## **ADDITION TO PARKER ESTATES SUBDIVISION**

APPLICATION NUMBER 6 DATE June 15, 2017

REQUEST Subdivision

# DETAIL SITE PLAN

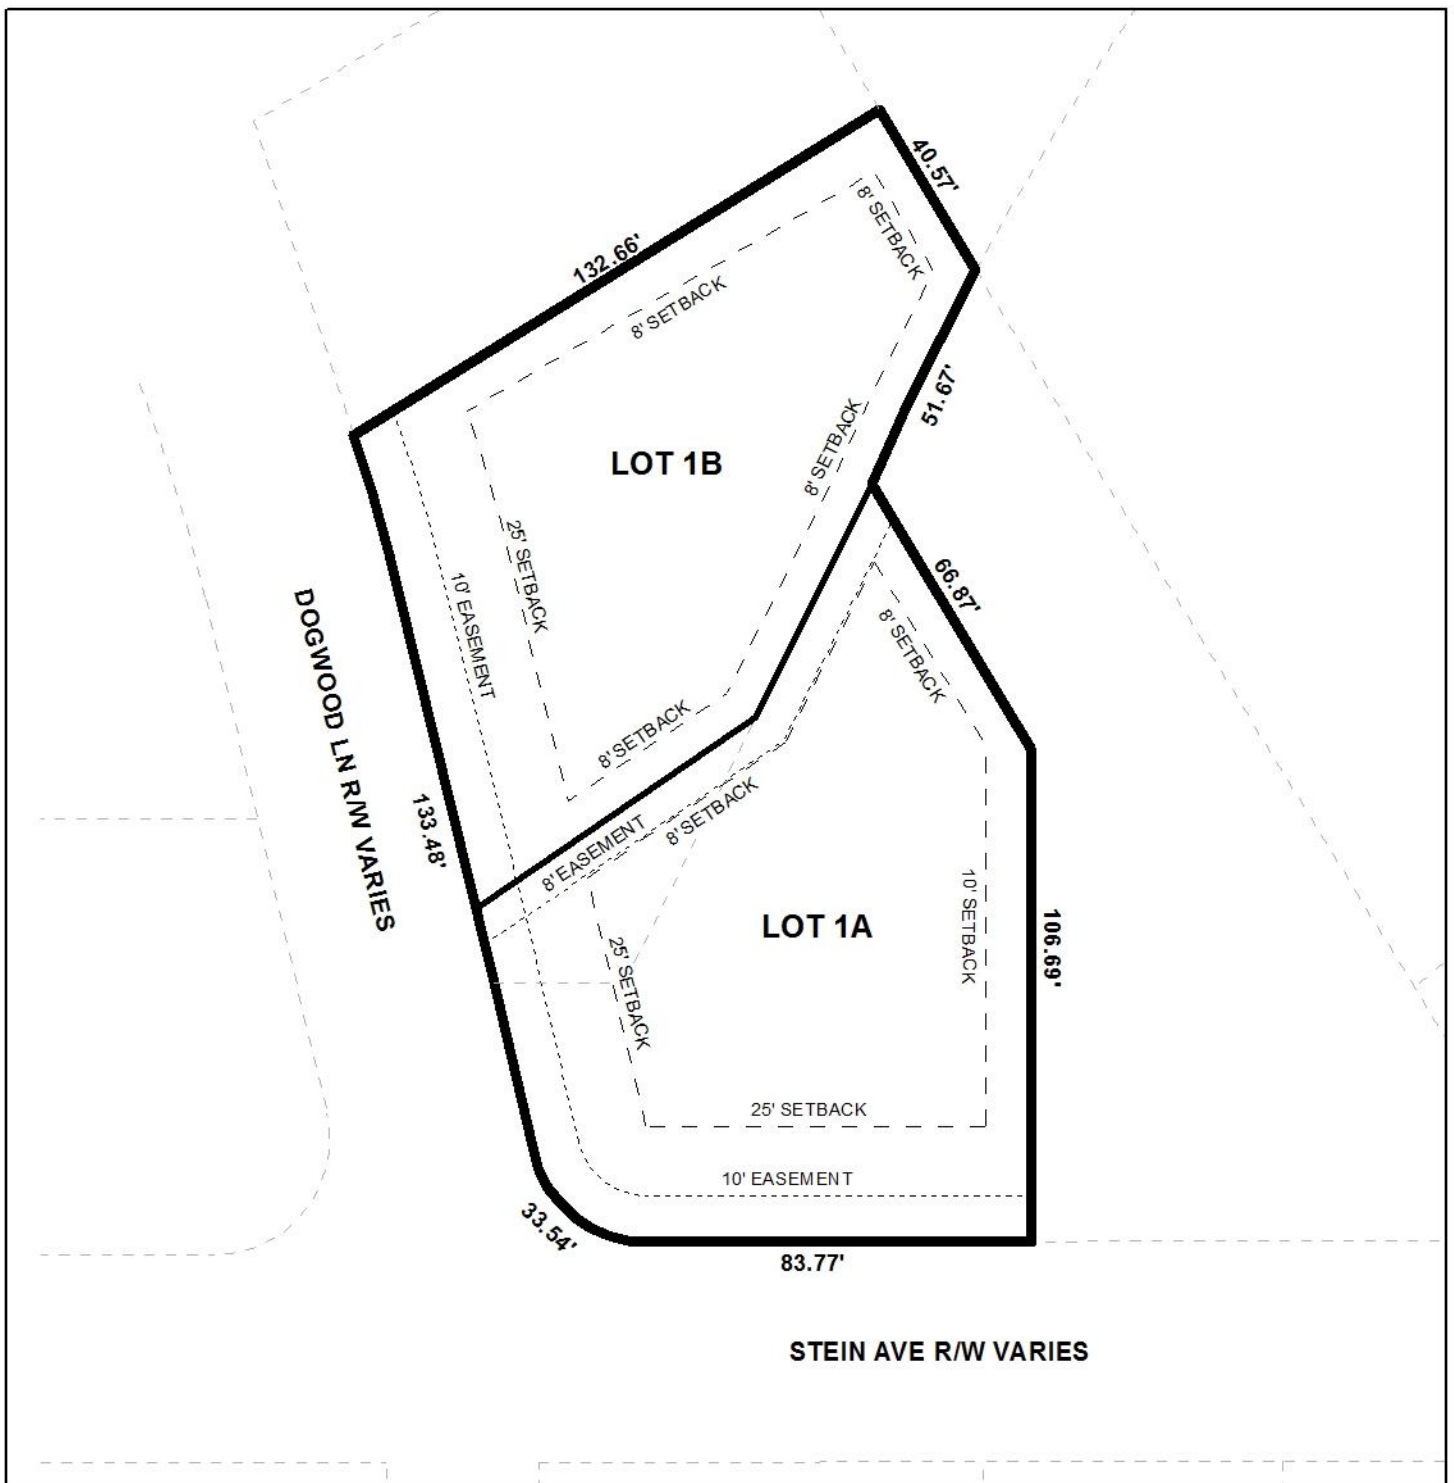
Proposed Lot 1-A has frontages on Stein Avenue, to the South, a minor street with curb and gutter requiring a 50' right-of-way width; and, Dogwood Lane, to the West, a minor street with curb and gutter also requiring a 50' right-of-way width. Proposed Lot 1-B also has frontage on Dogwood Lane, to the West. While the preliminary plat indicates the rights-of-way widths vary along both streets to which the site has frontage, dedication has nevertheless been illustrated to provide 25' from the centerline of each street and is adequate in that no additional dedications should be required.

A sufficient corner radius is illustrated at the intersection of Stein Avenue and Dogwood Lane; nevertheless, dedication may still be required on the Final Plat, if approved, per Section V.D.6. of the Subdivision Regulations.

Both proposed lots are irregularly shaped, but nevertheless meet the minimum size requirements of the Subdivision Regulations for lots served by public water and sanitary sewer. Their sizes are appropriately labeled in square feet and acres on the preliminary plat and, if approved, should be retained on the Final Plat; or, provision of a table providing the same information should suffice.

The 25-foot minimum building setback is also illustrated on the preliminary plat along both street frontages and should, therefore, be retained on the Final Plat, if approved.

It should be noted that the plat illustrates side and rear yard setbacks whose dimensions do not reflect the requirements of Section 64-3.C.1.e. of the Zoning Ordinance (8' minimum side yard setback, 20' minimum combined side yard setbacks). Moreover, with the exception of the 25' minimum building setback line, setbacks are not required to be illustrated on the Subdivision Plat. However, if side and rear yard setbacks are illustrated on the Final Plat, they must comply with Section 64-3.C.1.e. of the Zoning Ordinance.

Finally, a 10' utility easement is illustrated along the frontages of both lots, and a 7.5' drainage and utility easement is illustrated between both lots. As such, placement of a note on the Final Plat stating no structures shall be constructed in any easement should be required, if approved.

- 1) dedication of the corner radius at the intersection of Stein Avenue and Dogwood Lane per Section V.D.6. of the Subdivision Regulations, if necessary;

- 2) placement of a note on the Final Plat stating each lot is limited to its existing curb cut(s), with any changes in their sizes, locations, or designs to be approved by Traffic Engineering and conform to AASHTO standards;

- 3) retention of the lot sizes in square feet and acres on the Final Plat, or the provision of a table on the Final Plat providing the same information;

- 4) retention of the 25' minimum building setback line along both street frontages;
- 5) revision of the plat to either remove, or correctly illustrate side and rear yard setbacks in compliance with Section 64-3.C.1.e. of the Zoning Ordinance;
